Access Compliance Report Public Rights-of-Way (Curb Ramps)

Main Street: SILVERWOOD_DR Cross Street: KENSINGTON_RD Location: N

ADA ID: RPAT211201110437 Ramp Type: Type 1 - Perpendicular Diagonal Initial Pass/Fail: Pass Overall Compliance: No Severity Score: 14

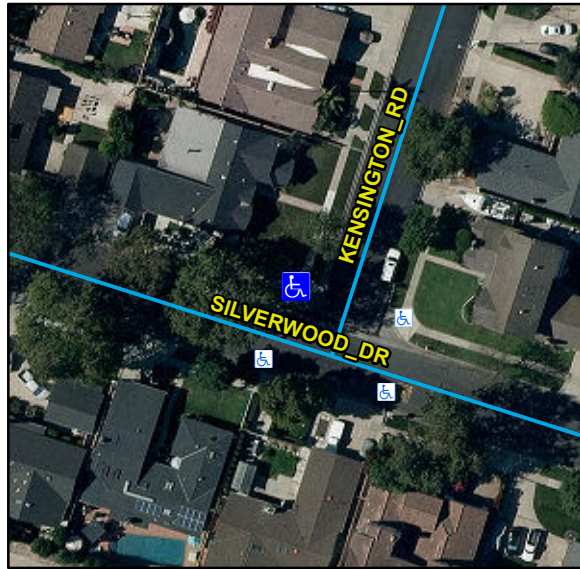
R204.3, R304.2.1, R304.2.2-Perp, R304.3.2-Para, R305, STD 1115

Remove & Replace Curb Ramp With Two New Directional Ramps or Equivalent.
